# COMMITTEE OF ADJUSTMENT COMMENTS FROM STAFF, PUBLIC & AGENCIES

**APPLICATION NUMBER:** A-52/15  
**LOCATION:** 5 Conroy Crescent  
**DATE AND TIME OF HEARING:** August 13, 2015 at 4:00 p.m.  
**OWNER:** Aboul Rahmaty  
**AGENT:** N/A  
**OFFICIAL PLAN DESIGNATION:** General Residential  
**ZONING:** Residential Semi-Detached/Duplex (R.2)

**APPLICATION NUMBER:** A-64/15  
**LOCATION:** 29 Crimea Street  
**DATE AND TIME OF HEARING:** August 13, 2015 at 4:20 p.m.  
**OWNER:** Michael Weber  
**AGENT:** N/A  
**OFFICIAL PLAN DESIGNATION:** General Residential  
**ZONING:** Residential Semi-Detached/Duplex (R.2)

**APPLICATION NUMBER:** A-66/15  
**LOCATION:** 38 Alice Street  
**DATE AND TIME OF HEARING:** August 13, 2015 at 4:40 p.m.  
**OWNER:** Michael Barber and Natalie Schlee  
**AGENT:** N/A  
**OFFICIAL PLAN DESIGNATION:** General Residential & Two-Zone Fringe  
**ZONING:** Specialized Residential Single Detached (R.1B-10) and lands within the Flood Fringe

SITE PLAN  
 LOT 104 PLAN 28 & 115  
 SCALE 1" = 20'-0"  
 METRIC 1:245

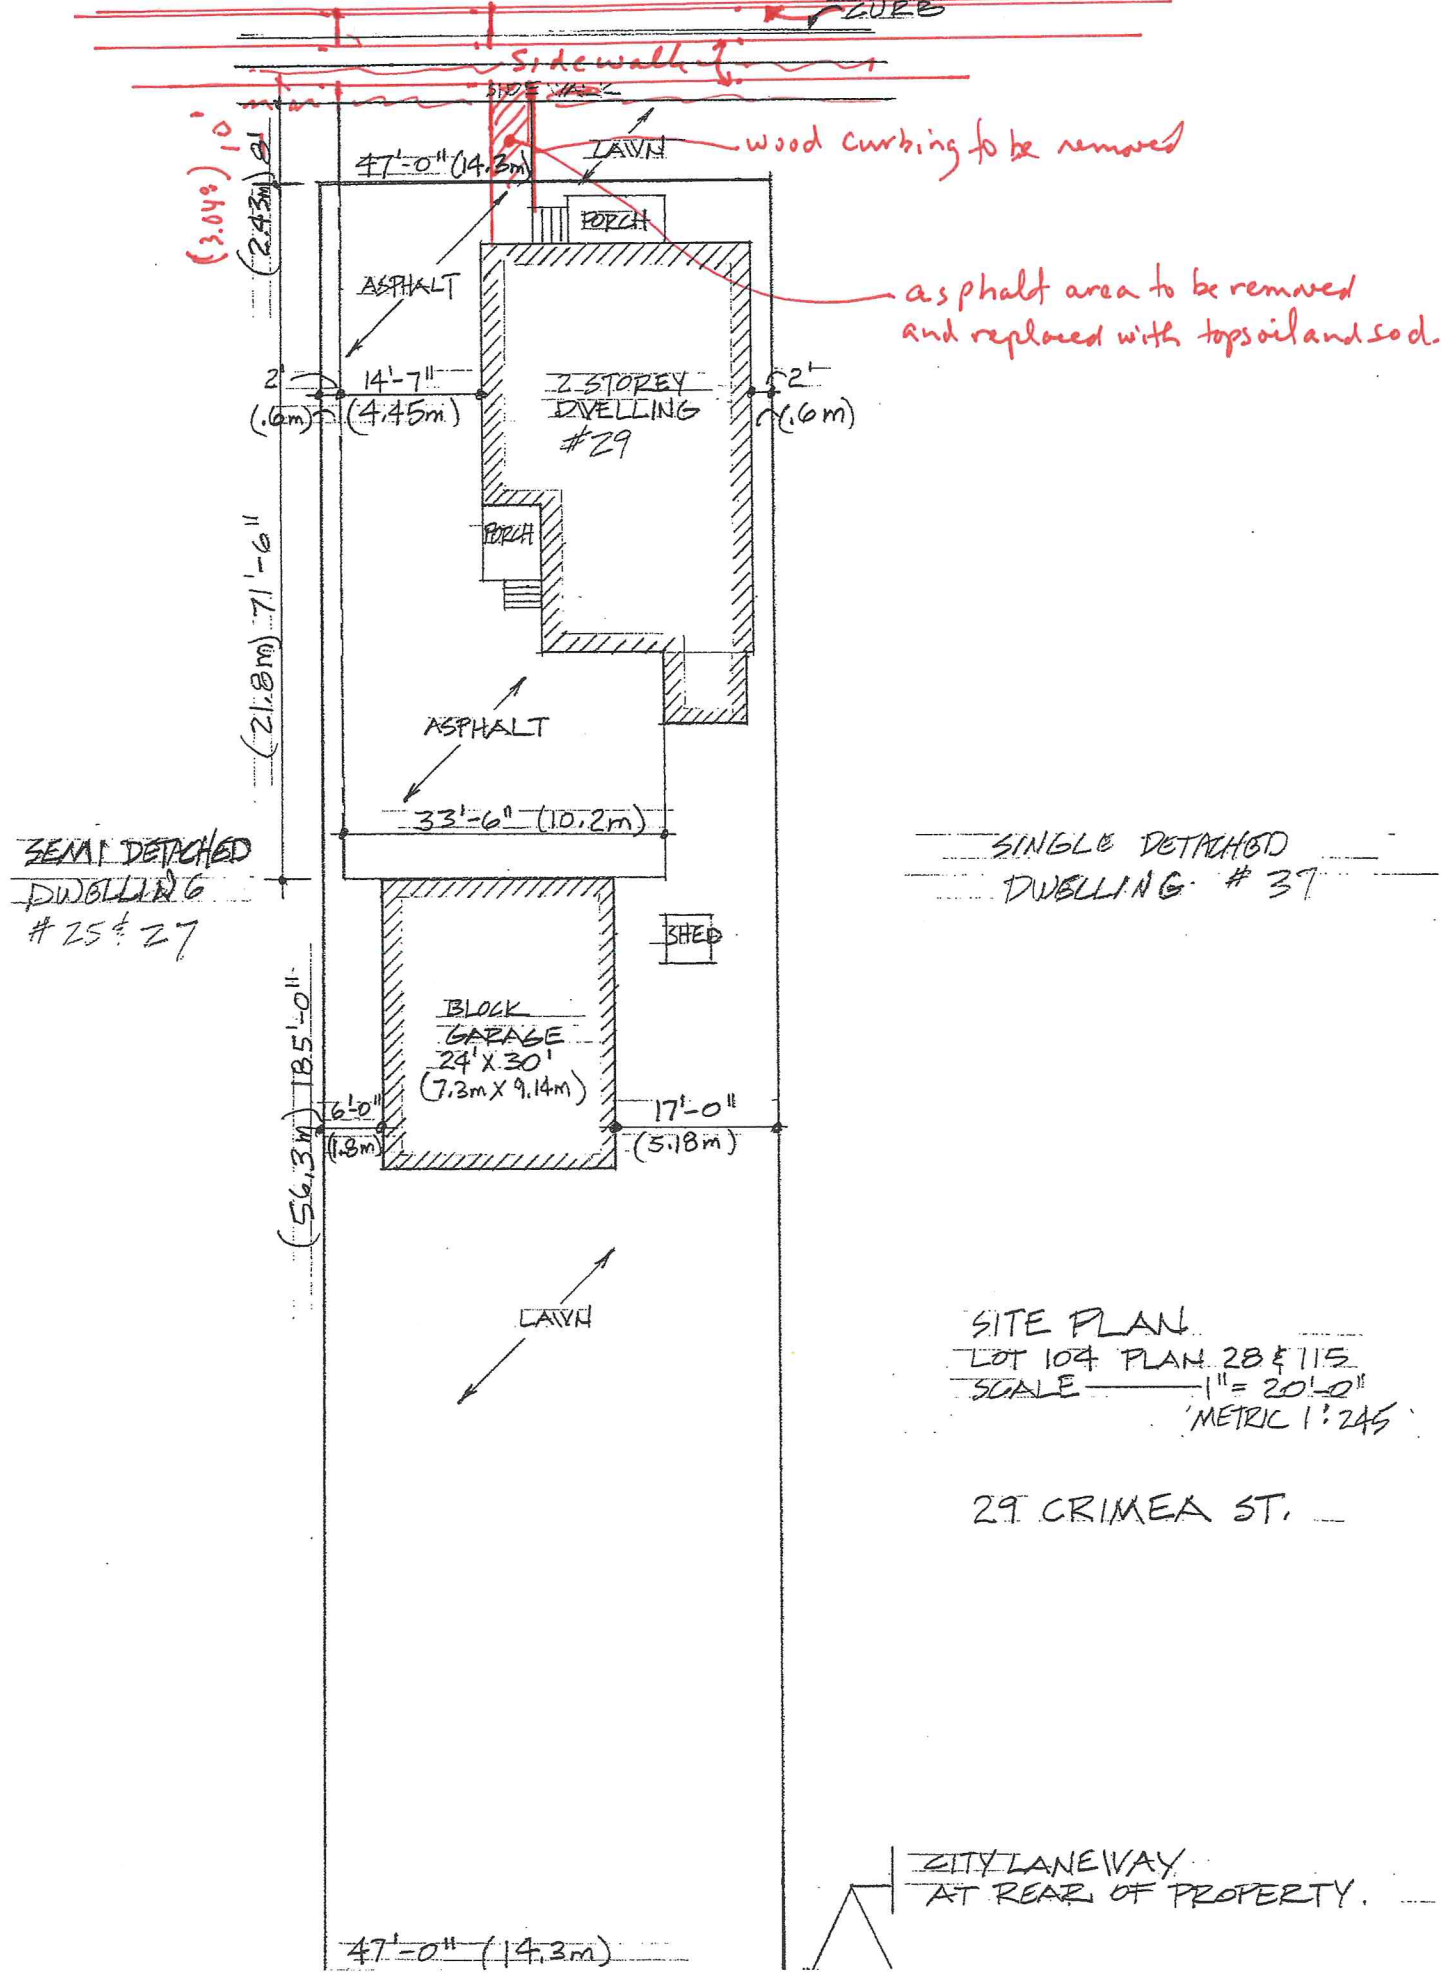
We have illustrated in red on the applicants site plan the existing driveway entrance, existing asphalt area and wood retaining wall that is to be removed and replaced with topsoil and sod, to assist the Committee.

1. That the owner pays the actual cost associated with the removal of the existing asphalt area and wood curbing within the road allowance, and the restoration of the boulevard with topsoil and sod, with the estimated cost of the works as determined necessary by the General Manager/City Engineer being paid, prior to the issuance of a building permit.

4. That the asphalt extending in front of the dwelling be removed and replaced with landscaping to the satisfaction of the Chief Building Official or his designate within 1 year of this decision.

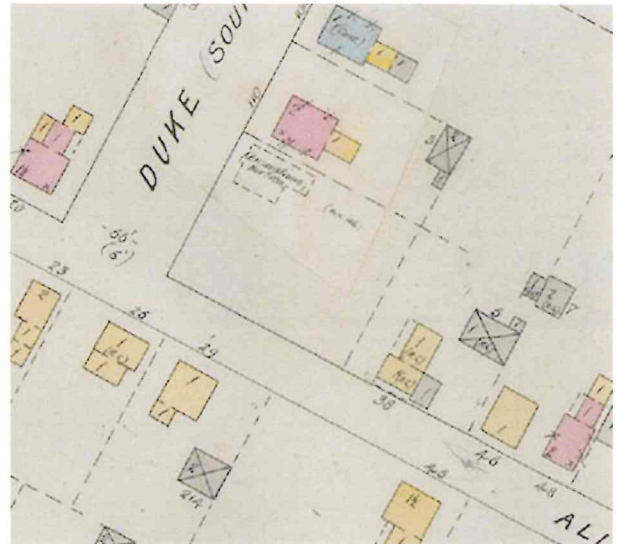
Although Heritage Planning has no objection to the proposed minor variance that would permit the side yard variance to be 3.3 m (1 ft) from the right lot line, and although the exterior materials of stone veneer (lower) and board and batten (upper) seem appropriate, the overall scale and massing of the proposed addition seems to be too tall and quite shallow in depth and, therefore, is disproportionate to the single-storey form of the original cottage. The proponent is encouraged to consider a lower roof pitch for the addition that

would be more compatible with the massing of the built heritage resource.
